189	
NO.	DATE	REVISION	APPROV.		
6/2/04		REPLACEMENT OF SWING GATE WITH SLIDING GATE			
5/27/04		ADDITION OF 12" CONC. CURB FOR SCREEN PLANTING			
HNTB ARCHITECTS ENGINEERS PLANNERS The HNTB Companies					
ARAPAHO ROAD EXTENSION					
SURVEYOR BOULEVARD TO ADDISON ROAD					
STA 37+00 TO 40+00					
SITWORK LAYOUT & DIMENSIONING PLAN					
TOWN OF ADDISON, TEXAS					
Design	DAB	Drawn	DAB	DATE	SCALE
Check	MP	Check	MP	6/3/04	VARIES
PROJECT NO.	25768	SHEET NO.	LA-02

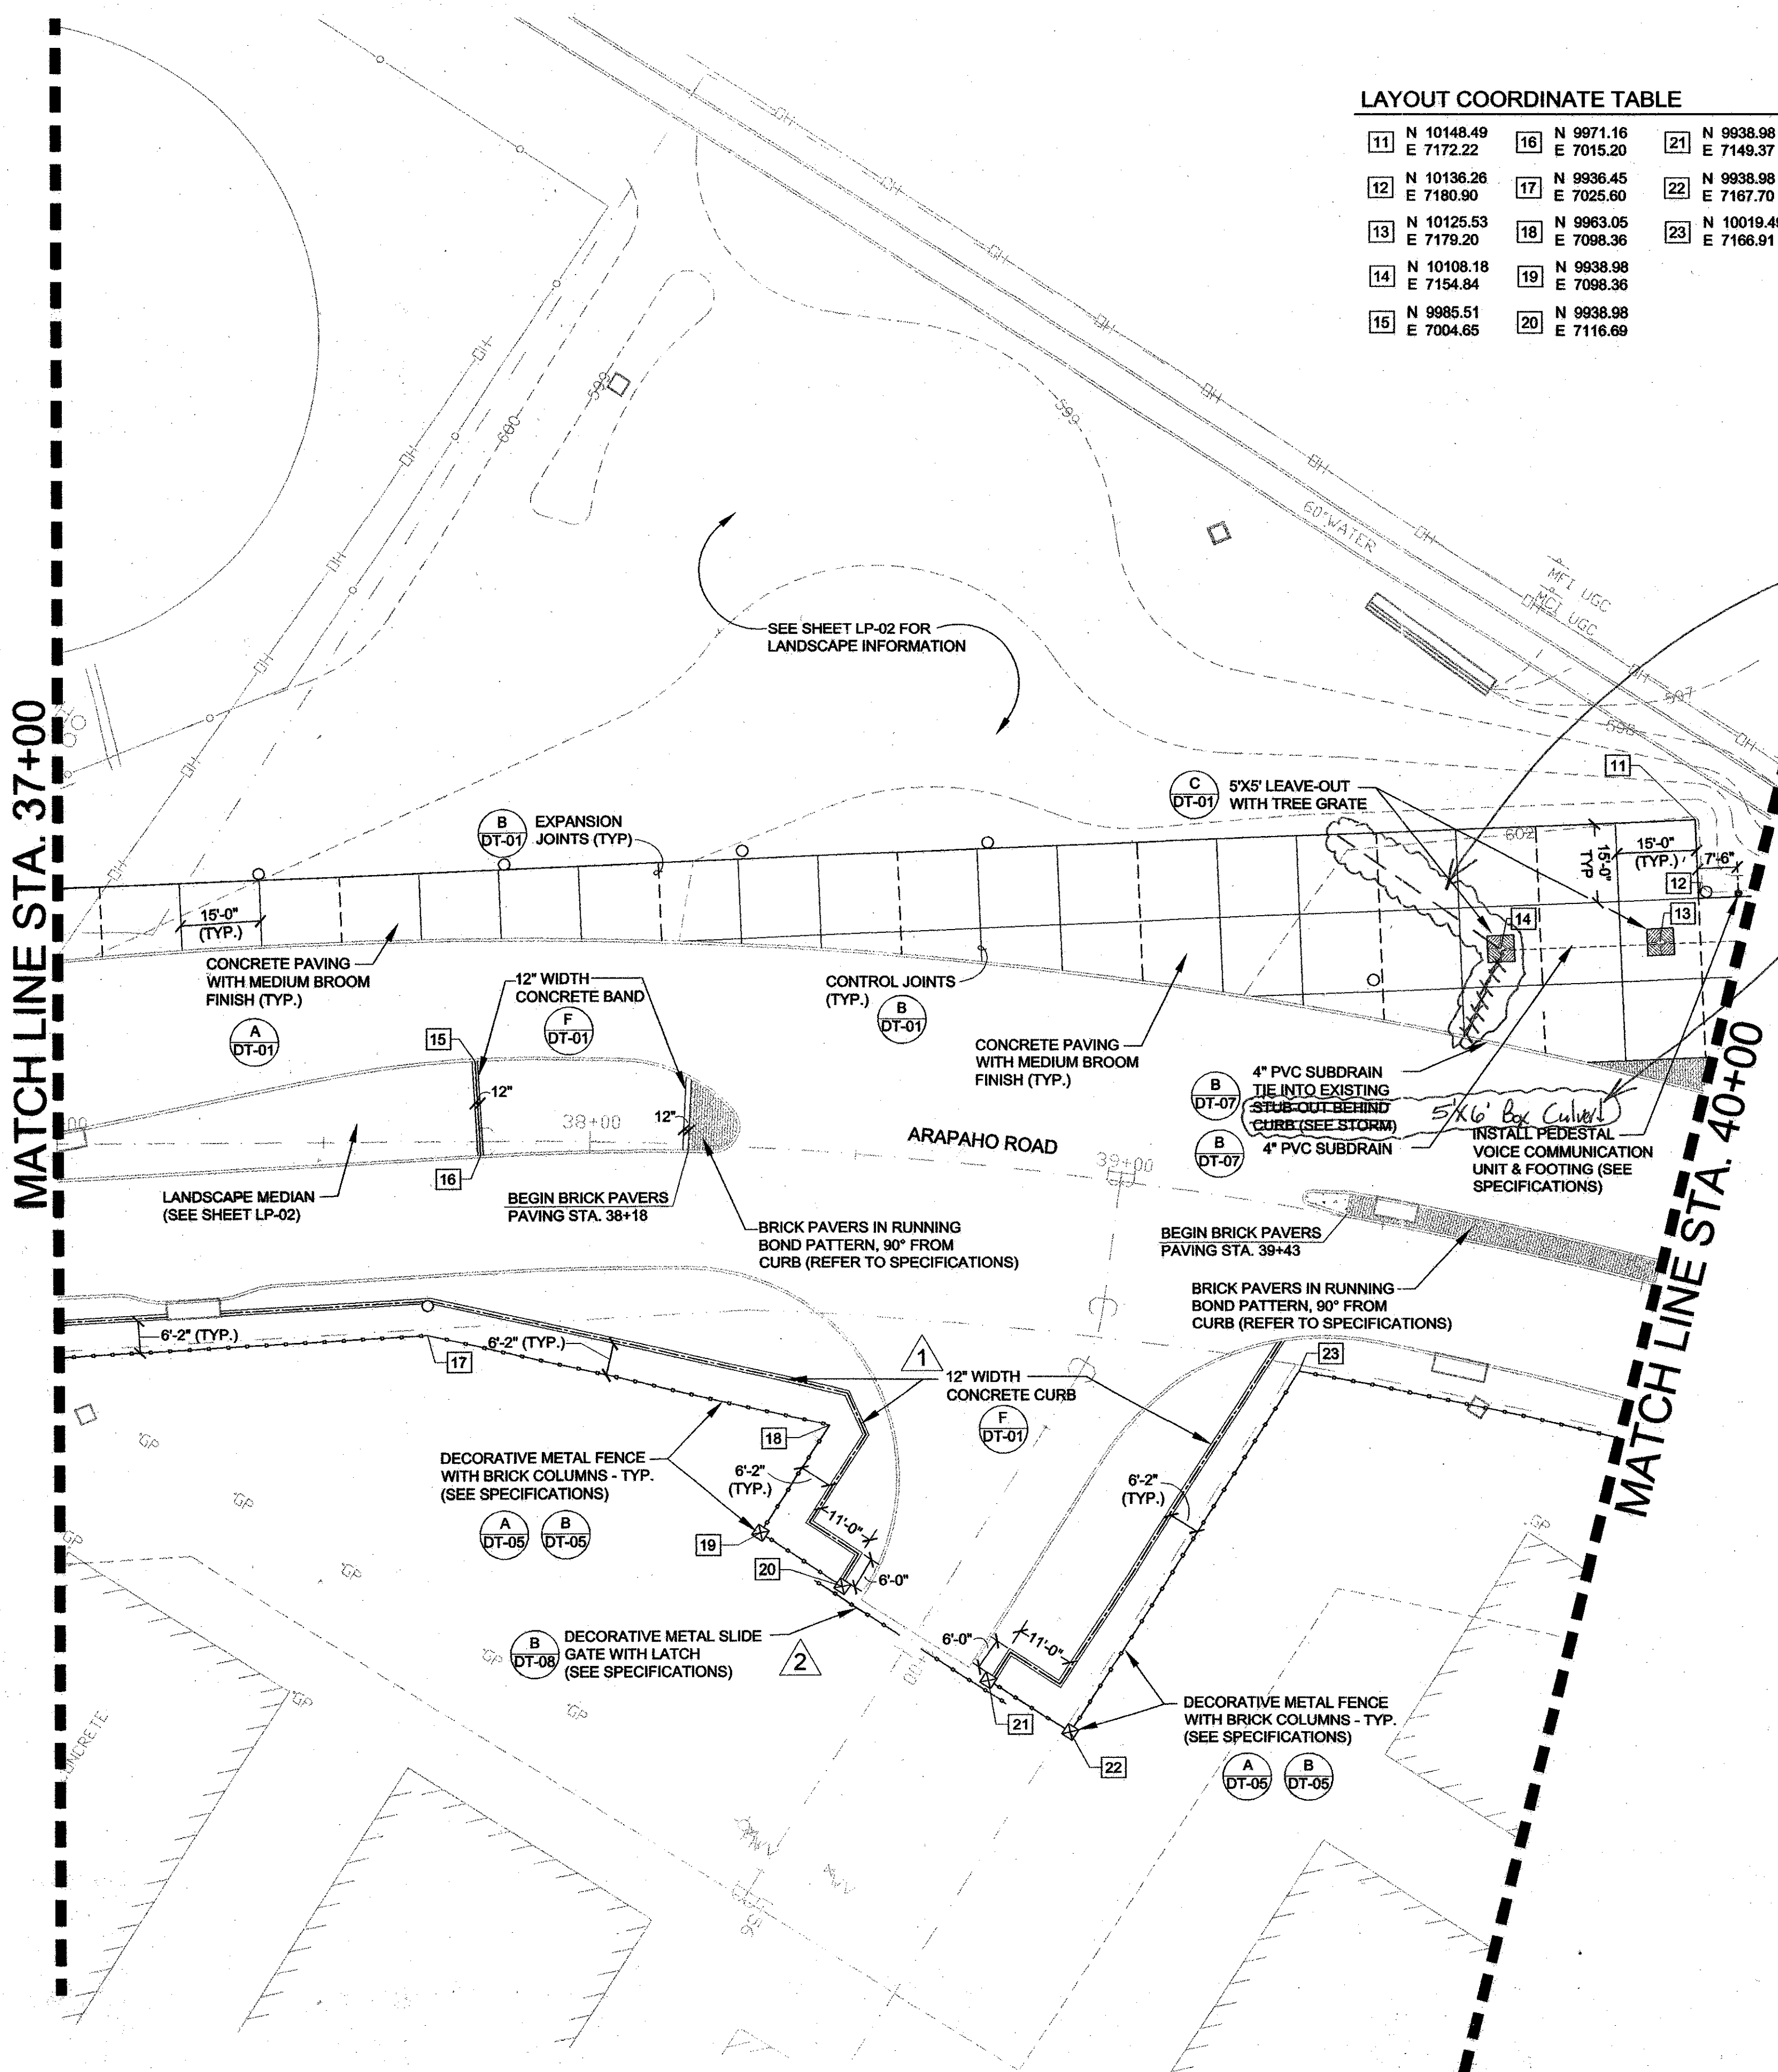
See RFI #043
Run 4" PVC Subdrain System in Trench into the 5'x6' Culvert. (Material B-2) Install 4" Pipe at Minimum of 1% Slope and connect to Box in the Upper 2' of the sidewalk.
